ARCHITECTURAL REVIEW BOARD STAFF REPORT

Project #/Name	ARB-2025-00031: Airport Industrial Development Complex
Review Type	Final Site Plan
Parcel Identification	03200000001700, 032000000017E3
Location	North side of Airport Rd., north and east of Timberwood Blvd. (Figure 1)
Zoned	Light Industry (LI), Entrance Corridor (EC)
Owner/Applicant	United Land Corp. of America (Hunter Wood) / Collins Engineering (Scott Collins)
Magisterial District	Rio
Proposal	To construct buildings to house light industrial flex office space, with associated site improvements, in multiple phases.
Context	The northern portion of the property is wooded, as is land to the north and northeast. Immediately to the west are institutional and industrial properties. Across Airport Rd. to the south is a mix of industrial, institutional and residential development.
Visibility	Parts of the proposed development will be visible from the Entrance Corridor street. Existing development to the west of Timberwood Blvd. will limit some views from the southwest. The property drops in elevation moving north, away from the EC street, which could also reduce visibility of portions of the development. Buildings 1-5 will have the mo

Figure 2: Overall Development Plan. Top: Initial Site Plan. Bottom: Final Site Plan

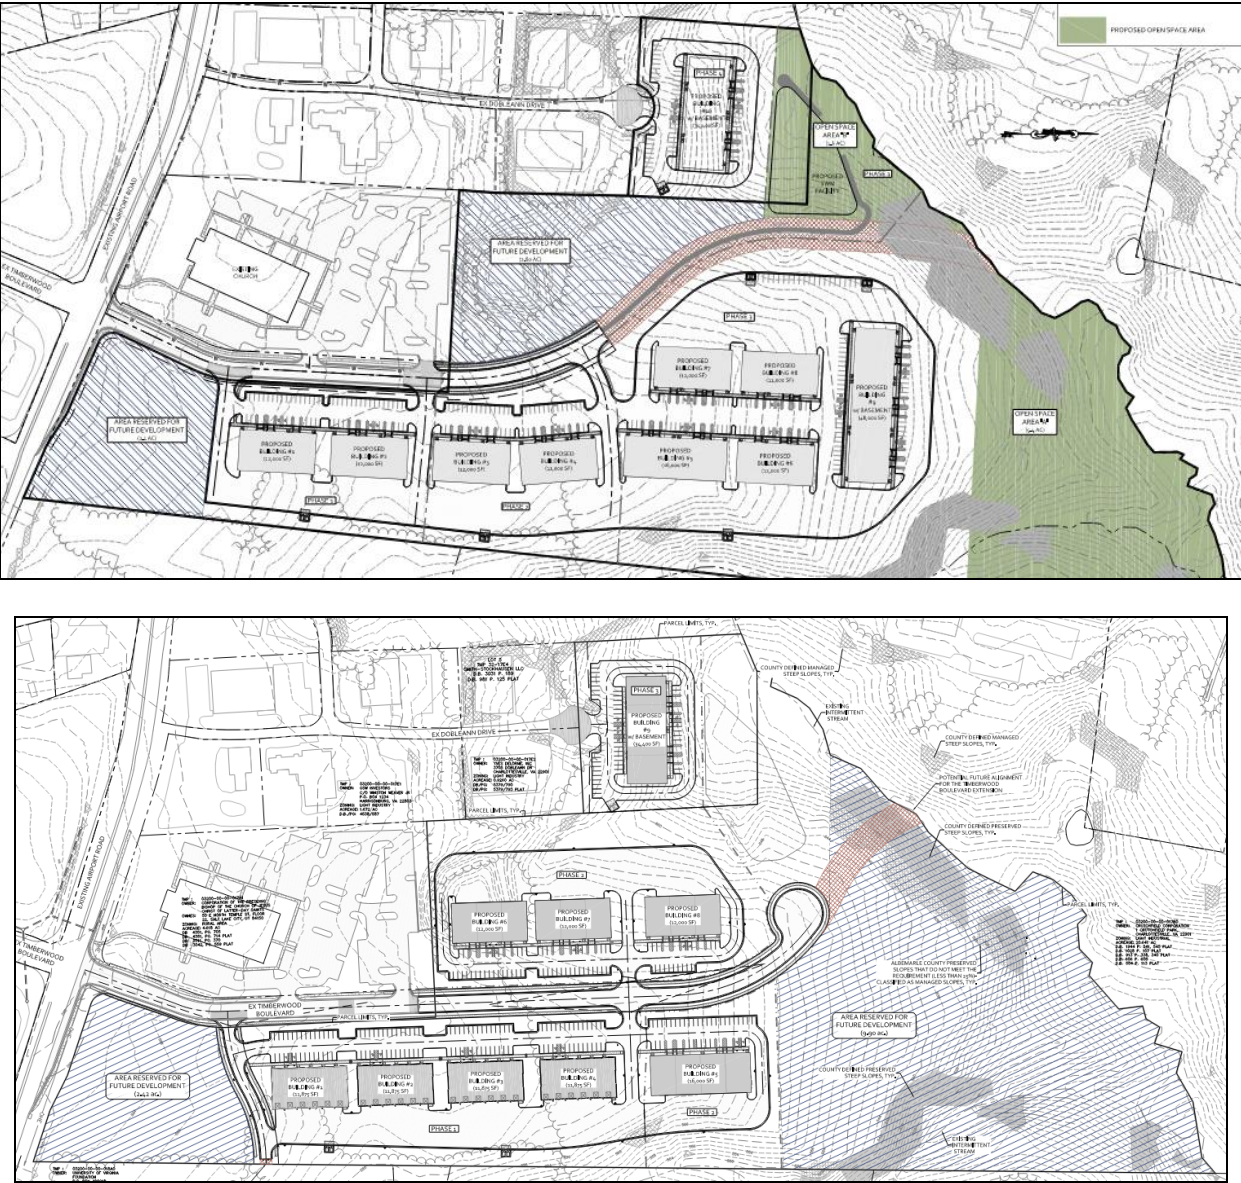
The ARB completed a review of the Initial Site Plan for this project on August 4, 2025 (SDP-2025-00095: Hollymead Flex Office Development) and recommended approval of the plan with the condition that the EC frontage landscaping be provided with Phase 1 of the development. (See Attachment 1 for the August 4, 2025, action letter and Figure 2 for a comparison of the Initial and Final Overall Development Plans.)
